Name of Dam: Camp Shenandoah Dam.
Location: Augusta County, State of Virginia
Inventory Number: VA 01515

PHASE I INSPECTION REPORT
NATIONAL DAM SAFETY PROGRAM.

Camp Shenandoah Dam (VA 01515).
Potomac River Basin. Augusta County,
State of Virginia. Phase I Inspection
Report.

PREPARED BY
MICHAEL BAKER, JR., INC.
BEAVER, PENNSYLVANIA 15009

- CAMP SHENANDOAH DAM, VIRGINIA -
SKETCH OF EXISTING SIDE CHANNEL SPILLWAYS

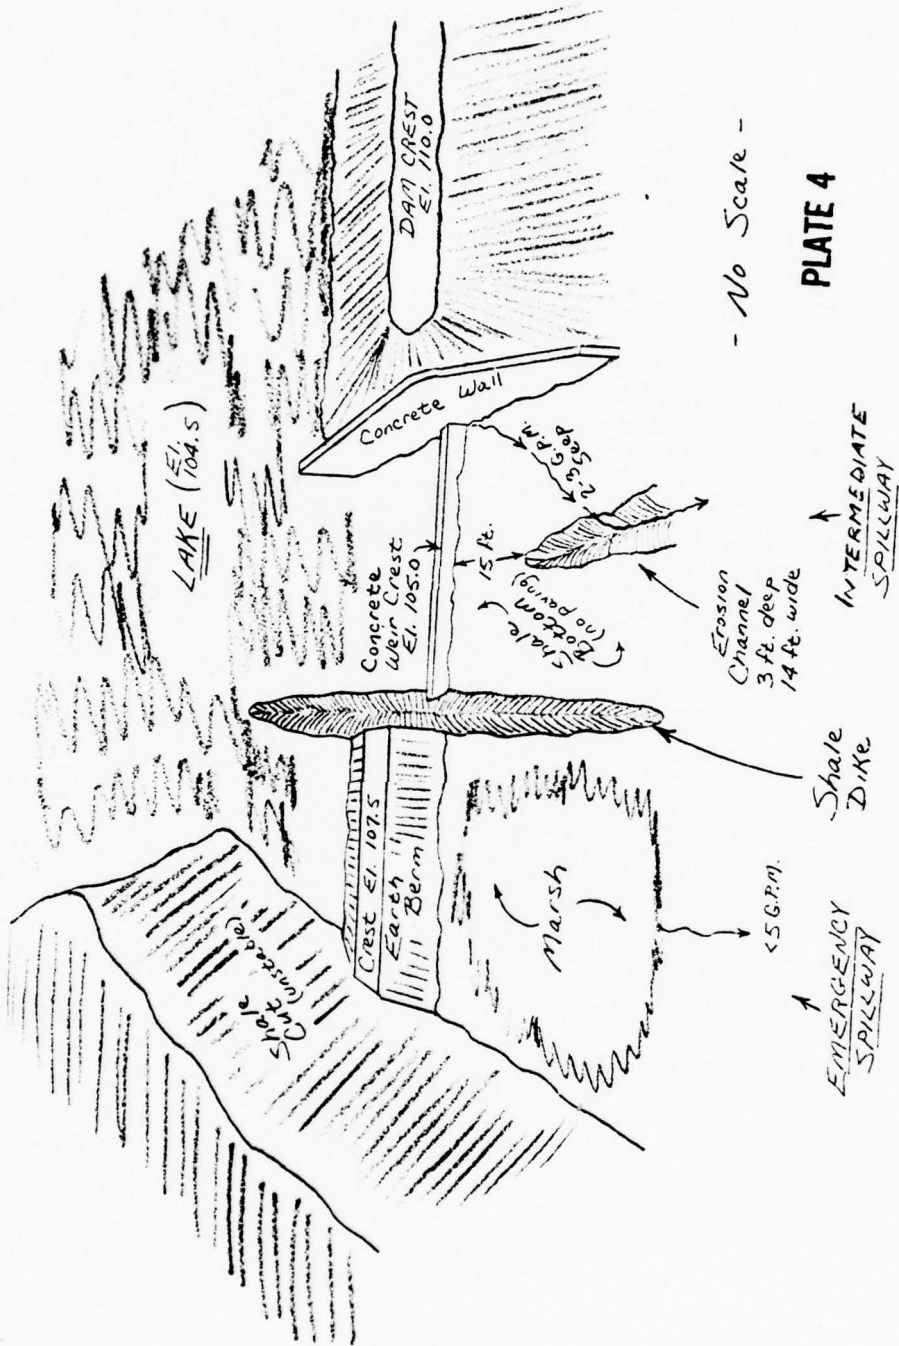
Two rock-cut side-channel spillways are situated side by side on the south end of the dam separated by a 20 feet wide shale bedrock dike. Plates 1 and 4 show these two spillways. In this report, the lower elevation spillway is called the intermediate spillway, and the higher elevation structure is called the emergency spillway. The intermediate spillway is approximately 45 feet wide at its base and has a concrete weir with a crest at elevation 105.0 (assumed datum). The emergency spillway is about 47 feet wide at the base and is crossed by an earth berm whose crest is situated at elevation 107.5 (assumed datum).

The approach and discharge channels of the two spillways are heavily overgrown and clogged with heavy debris (see Photos 3 and 4). A deep erosion channel in shale bedrock in the discharge channel of the intermediate spillway has rapidly progressed to within 15 feet of undercutting the concrete weir. The erosion is likely to continue, because the bedding orientation (strike N. 65° E., dip SE. 25°) is such that running water is essentially able to get under and lift the strata by the bedding planes.

The intermediate spillway was not constructed as indicated by the design details. The compacted clay liner with overlying concrete pavement is absent. It is unknown if the concrete weir extends to any appreciable depth forming a seepage barrier.

An approximate three to five g.p.m. clear seep is occurring under the north end of the concrete weir of the emergency spillway (see Photo 5). It is suspected that this clear seep is occurring through nearly vertical joints in the underlying shale which are oriented about in-line with the longitudinal axis of the spillway (joint strike N. 80° E., dip NW. 83°). This clear seep could undercut the weir.

A heavily tree covered berm constructed of clayey fill acts as the crest of the emergency spillway. The crest is at elevation 107.5 (assumed datum) (2.5 feet above the crest of the intermediate spillway). The design width across the crest of the berm was eight feet; actual width is a maximum of four to five feet. The width at the base is approximately 20 feet. A clear seep of less than five g.p.m., in the form of a marshy area, was observed in the discharge channel of the emergency spillway just below the berm (see Photo 6). Seepage may flow through the berm or through joints in the underlying shale.

- 5) Monitor the clear seep that is occurring below the north end of the concrete weir of the intermediate spillway to determine if undercutting might occur. If the potential exists, a compacted clay liner protected by riprap on the upstream side of the weir or similar abatement measure may be necessary.

- 6) A method of stopping the erosion in the intermediate spillway discharge channel is necessary. Backfilling the existing erosion channel and paving may be required to accomplish this.

- 7) A compacted clay liner on the upstream side of the berm in the emergency spillway may be necessary to prevent piping. This berm should also be widened and made more erosion resistant by riprap or other acceptable means.

PHOTO 1. Overflow Intake Tower

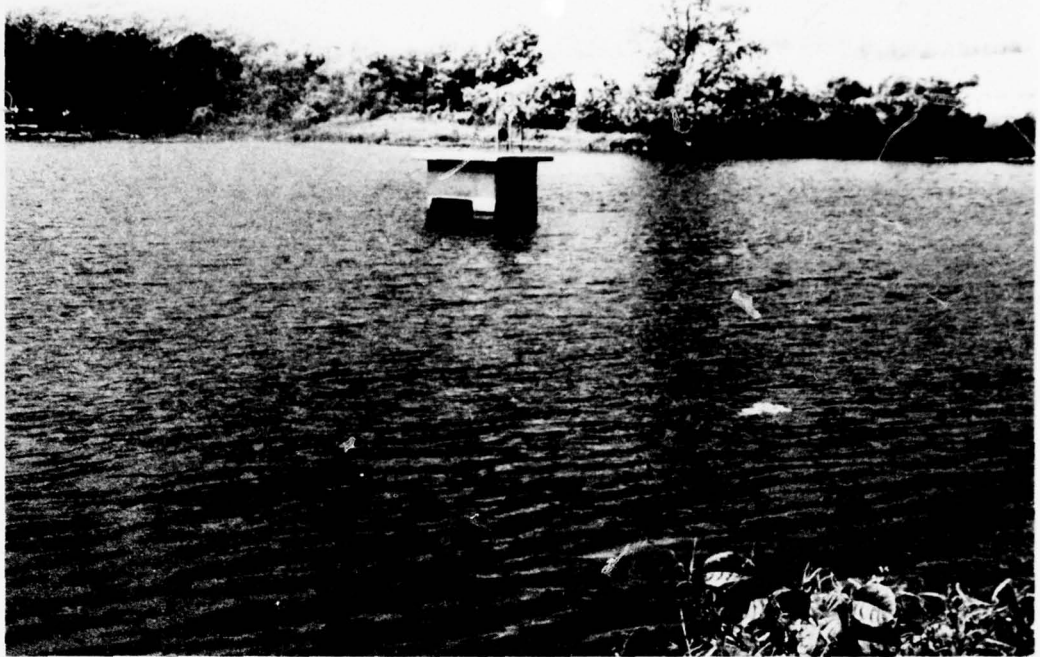
- 3.1.3 Appurtenant Structures: The inlet structure, outlet pipe and emergency gate are generally in good condition. However, the mesh of the trash rack (see Photo 1) on the intake tower is small (three-fourths of an inch) and could easily clog. The ladder for access to the tower is rusted through in a few places.

Approximately one-half of the intake tower trash rack was clogged with small debris at the time of the inspection.

- 8) Riprap around the outlet conduit and immediate discharge channel.
- 9) Replace the intake tower trash rack (three-fourths of an inch mesh) with larger mesh or a bar screen. Repair or replace the intake tower access ladder.

- 1) Place riprap around the principal spillway outlet and its immediate discharge channel.
- 2) Replace the intake tower trash rack with larger mesh screening or a bar screen.
- 3) Repair or replace the intake tower access ladder.
